PLAN CHANGE AS AMENDED BY THE HEARING COMMITTEE

***Proposed District Plan
Change 60***

Churton Park Suburban Centre Rezoning

12 February 2007
Wellington City District Plan

Appendix 89 Churton Park Village Concept Plan

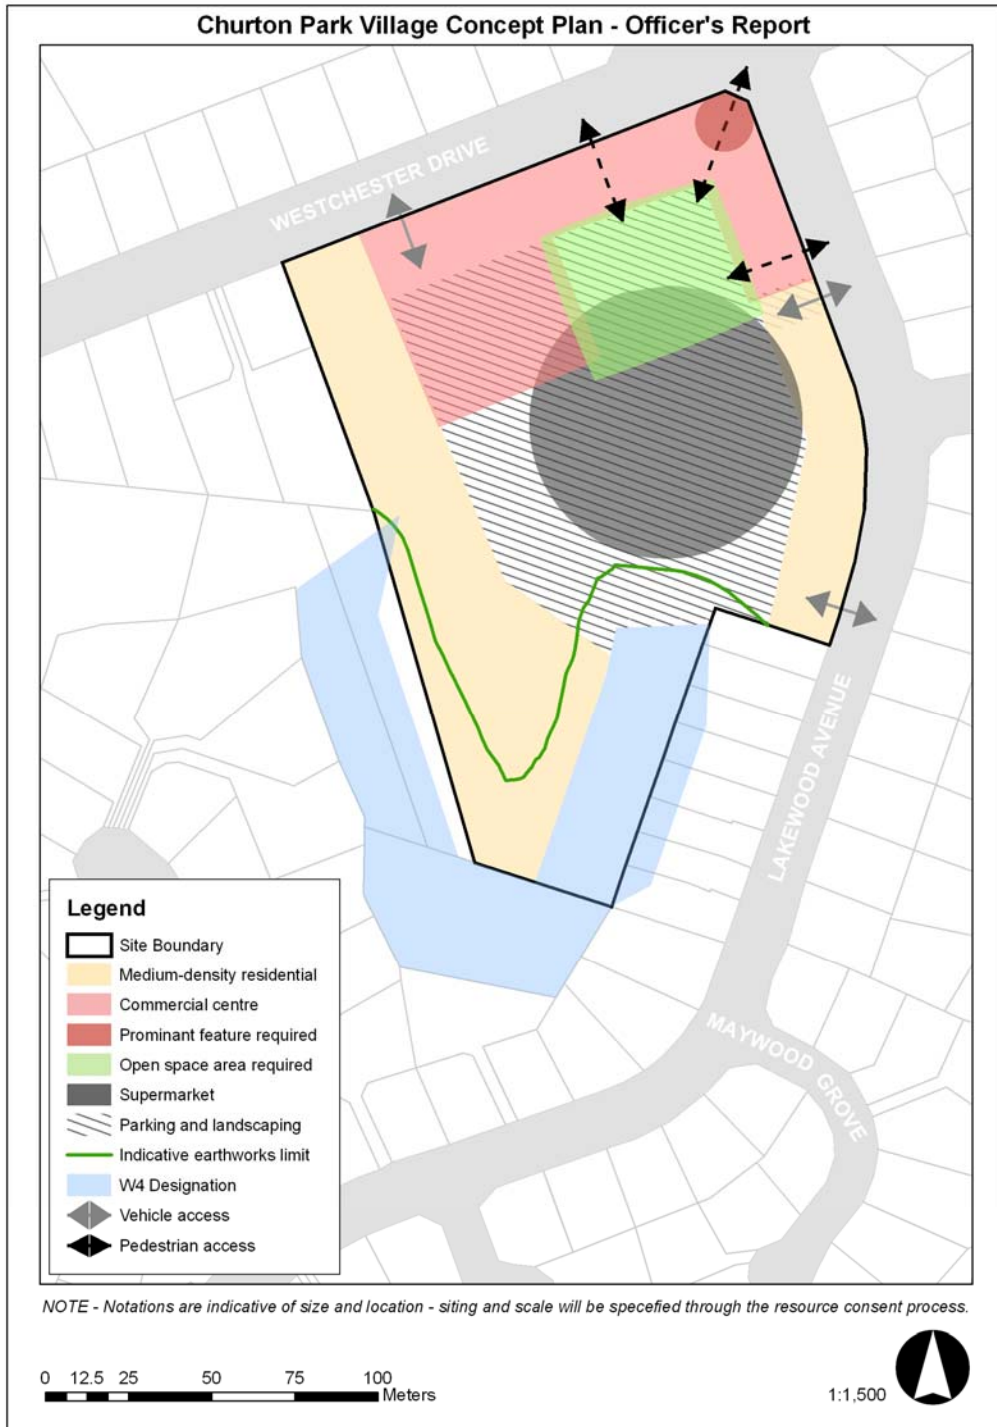
The different activity areas shown on the map do not represent the absolute location, footprint or specific land area to be used. Rather, these are diagrammatic representations of the general locations for buildings and activities. There is no specific requirement to either develop adjoined or separate buildings in any on part of the village. The final size, location and design of any component of the village required by the Concept Plan and shown on the map will be assessed through the resource consent process. Any subdivision will also be assessed through the resource consent process for compliance with the requirements and compatibility with the map of the Concept Plan. Additionally, given that timing of development or subdivision of any part of the village is uncertain, the Concept Plan anticipates any balance areas not being developed, but remaining in grass cover or be landscape planted awaiting development. In particular, the plan does not intend that undeveloped areas be temporarily developed or used for car parking.

1. A supermarket shall be located ~~in~~ toward the centre of the village and:
 - Shall be orientated toward (i.e. visually connect with) the commercial centre and open space area shown on the concept plan map; and
 - Shall fully activate any elevation(s) that front directly onto or face directly toward the open space area shown on the concept plan map; and
 - Shall activate a part of any elevation that directly abuts or faces onto any other 'public space' (as defined by the Plan), and shall articulate the remainder of any such elevation; and
 - Shall be serviced from the rear, southern, aspect; and
 - May have a pedestrian link to or a pedestrian entrance on a street frontage. Any such portion of building on a street frontage shall provide verandah cover over the footpath.

6. A dedicated **open space area**, free from vehicles and car parking, must be created adjacent to the commercial activities and be provided with visual and physical connections to the public street. The exact number and locations of these connections will ultimately depend on building design and layout. The open space area and connections shown on the map are indicative in terms of size and location. The open space area will not occupy all the area identified green on the map, but shall fit within that location.

9. There shall be at least one main **vehicle access** providing for entry to and/or exit from the village on each street frontage, in addition to access points for residential activities. The concept plan map shows 2 vehicle accesses on Lakewood Ave but that is indicative only not essential. A Traffic Engineers Assessment shall accompany each proposal involving provision of pedestrian access and vehicle access for any purpose. That report shall consider requirements 9 to 12 and 14, and include an assessment of effects on road safety, whether or not traffic calming measures are required on public roads, appropriateness of vehicle access location, type and volume of traffic use anticipated for

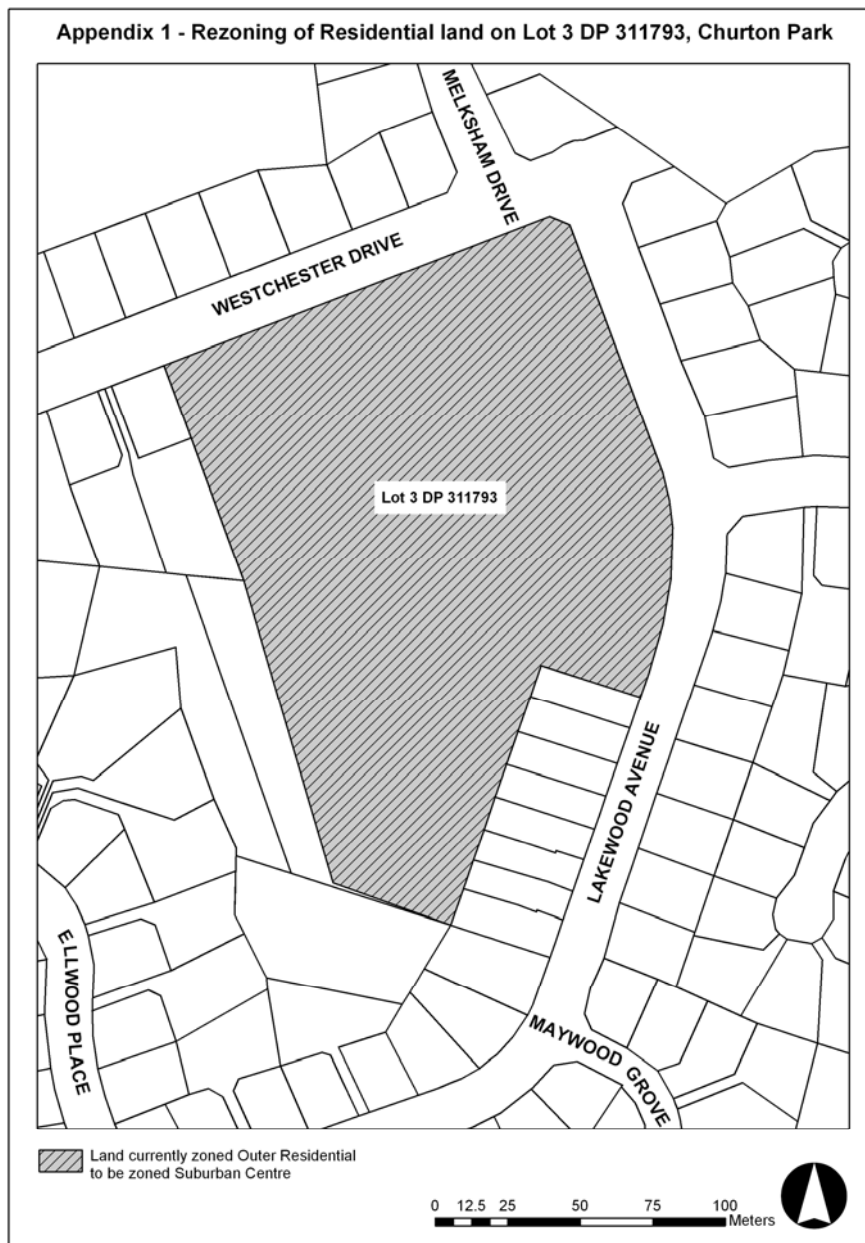
9.0 Amend planning map 26 by colouring the site on the south west corner of Westchester Drive and Lakewood Avenue for Suburban Centres zone as shown:
